Access Compliance Report

Public Rights-of-Way

(Curb Ramps)

Intersection ID: 31219	Main Street: HEADQUARTERS_FARM_RD	Cross Street: WESTBURY_GLEN_CT	Location: NW
ADA ID: E374451E0AFB	Ramp Type: Perp	Initial Pass/Fail: Fail	Overall Compliance: No
Severity Score: 17.5			
Codes/Mitigation Info/Possible Solution		Field Measurements/Component Compliance

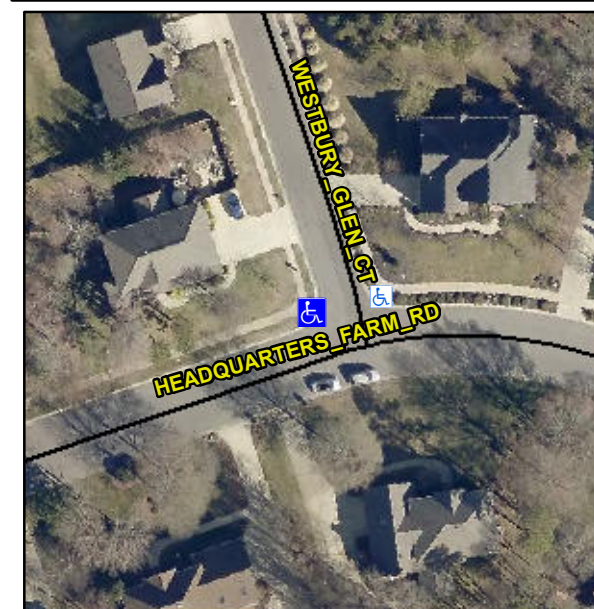
Not Found, R304.5.1

Compliance	Description	Data	Compliance	Description	Data
N/A	Ramp Length (in)	66.0	Yes	Ramp Slope (%)	5.0
No	Ramp Width (in)	33.0	Yes	Ramp XSlope (%)	1.1
N/A	Flare Type LT	N/A	N/A	Flare Type RT	N/A
N/A	Flare Slope LT (%)	N/A	N/A	Flare Slope RT (%)	N/A
N/A	Flare Traversable LT?	N/A	N/A	Flare Traversable RT?	N/A
N/A	Landing Length (in)	N/A	N/A	DWS Provided?	N/A
N/A	Landing Width (in)	N/A	N/A	DWS Contrast?	N/A
N/A	Landing Slope (%)	N/A	N/A	DWS Length (in)	N/A
N/A	Landing X Slope (%)	N/A	N/A	DWS Full Width?	N/A
N/A	Landing Curb? (Y/N)	N/A	N/A	DWS Offset (in)	N/A
N/A	Shared Landing?	N/A			
N/A	Gutter Ponding?	N/A	N/A	Gutter Slope (%)	N/A
N/A	Gutter Lip Ht (in)	N/A	N/A	Gutter X Slope (%)	N/A
N/A	Painted X Walk1?	No	N/A	Painted X Walk2?	N/A
	X Walk 1 Direction	To E		X Walk 2 Direction	N/A
N/A	X Walk 1 Width (in)	N/A	N/A	X Walk 2 Width (in)	N/A
	X Walk 1 Slope (%)	3.6		X Walk 2 Slope (%)	N/A
	X Walk 1 X Slope (%)	1.9		X Walk 2 X Slope (%)	N/A

Remove & Replace Entire Ramp.
